**2. REVISED DRAFT PLAN CONDITIONS -
HISTORIC ELMWOOD COUNTRY LOT SUBDIVISION -
TOWNSHIP OF WEST CARLETON**

That Council approve the revised draft conditions (attached as Annex A) for draft plan of subdivision 06T-98025.

SUBJECT/OBJET **REVISED DRAFT PLAN CONDITIONS-
HISTORIC ELMWOOD COUNTRY LOT SUBDIVISION
TOWNSHIP OF WEST CARLETON**

DRAFT PLAN FOR HISTORIC ELMWOOD COUNTRY ESTATE LOTS

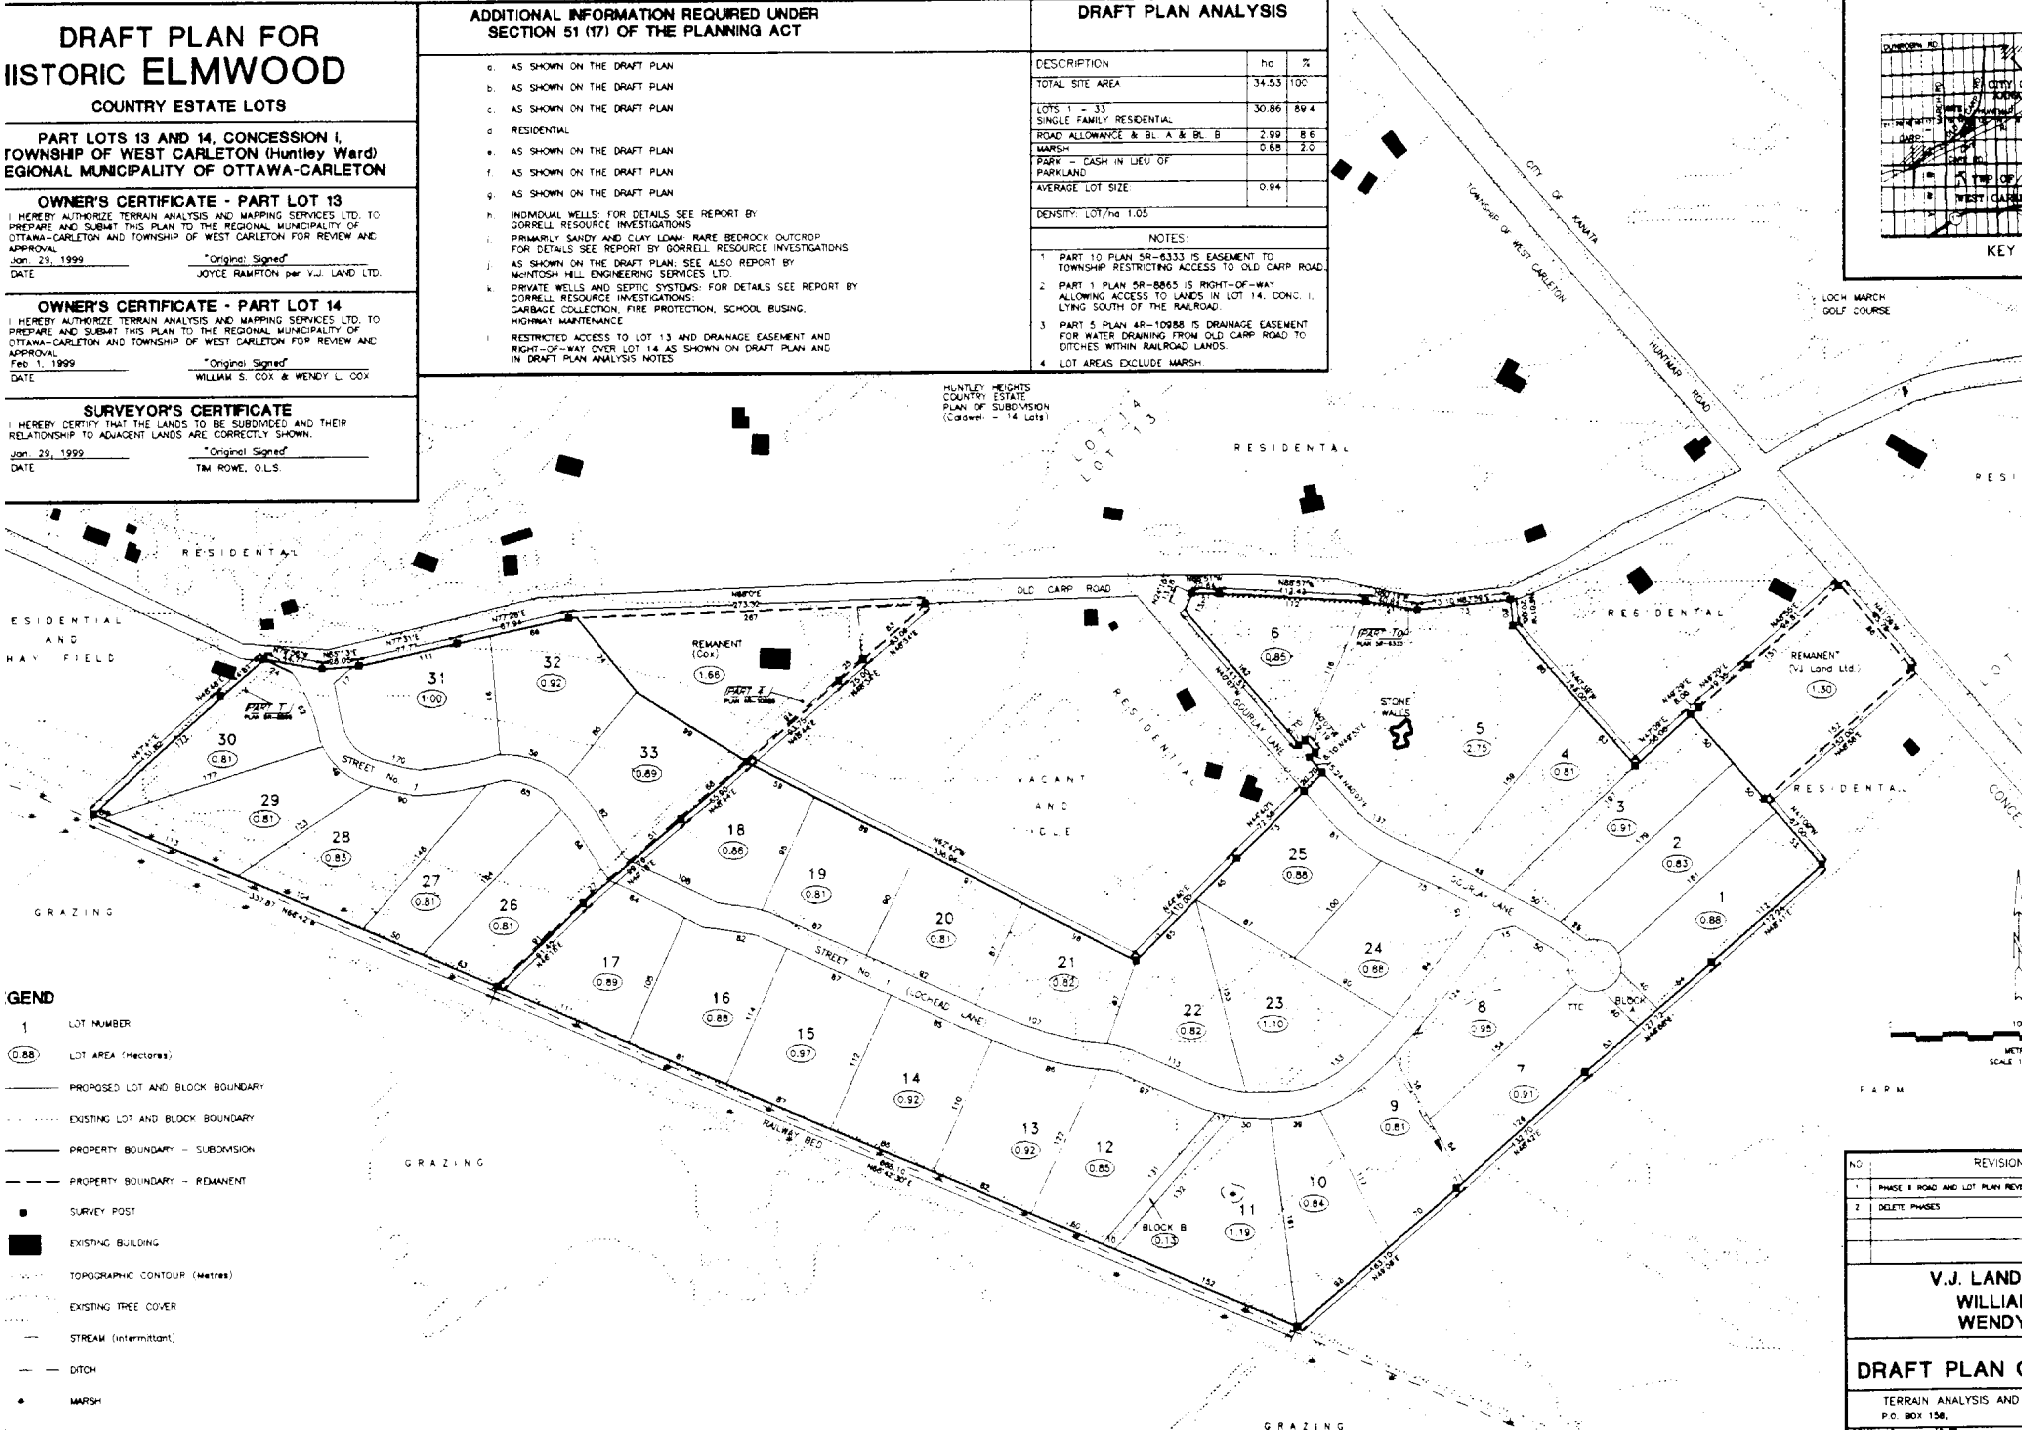
- Condition 1 be amended to include reference to the Blocks which are set aside for the future access to the Honeywell lands and to the railway, as shown on the revised plan as Blocks “A” and “B”

- Condition 11 be amended to accept Block “B” for access to the railway lands has been shown on the revised draft plan, and to change ‘Street No. 1’ to “Lohead Lane”

1. This approval applies to the draft plan certified by, OLS, dated 29 January 1999, as amended on 26 June 2000 showing 33 residential lots, 1 Block for future road purposes and 1 block to provide a pathway to the railway.

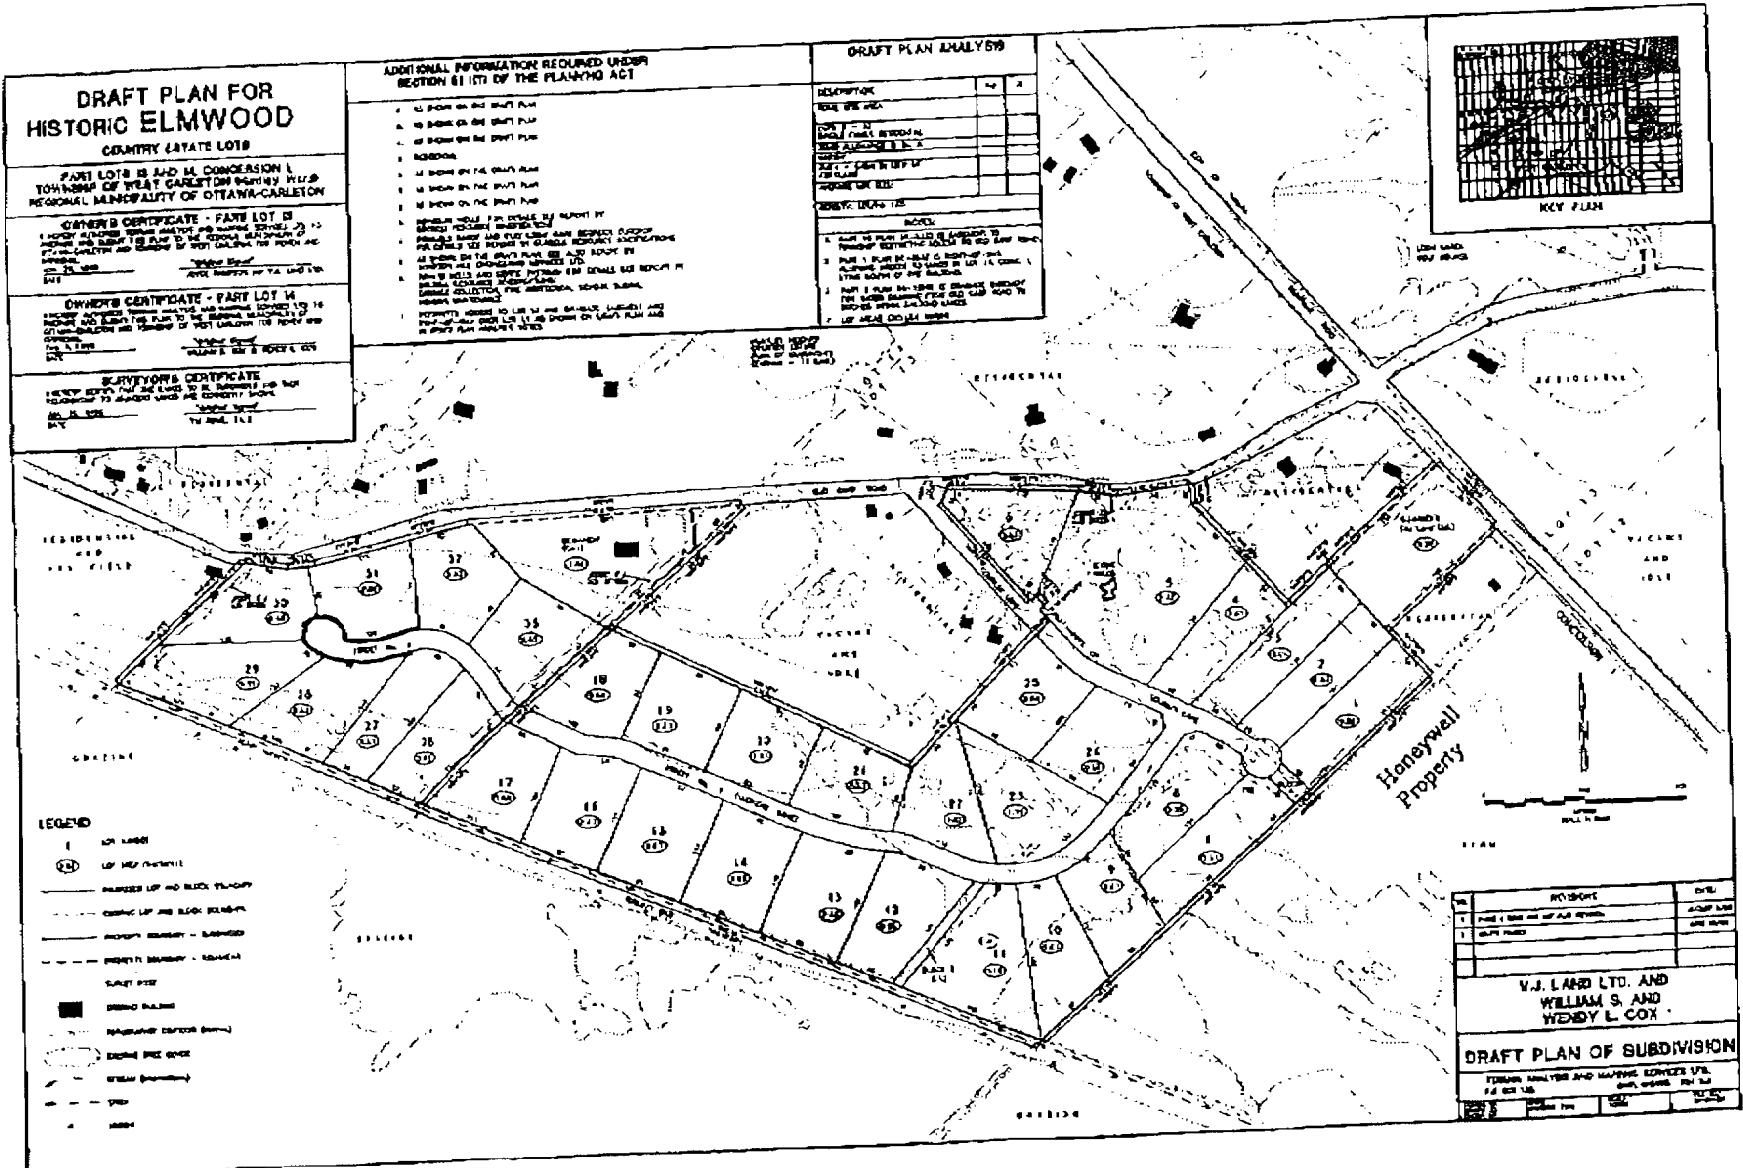
Please consider the cul-de-sac option at the west end of Lockheed Lane (Schedule A) rather than a 3 way stop intersection at the Old Carp Rd. (Schedule B).

Any health and safety benefit gained by having a second access would be grossly overshadowed by the health and safety hazard that you would create with this dangerous intersection.
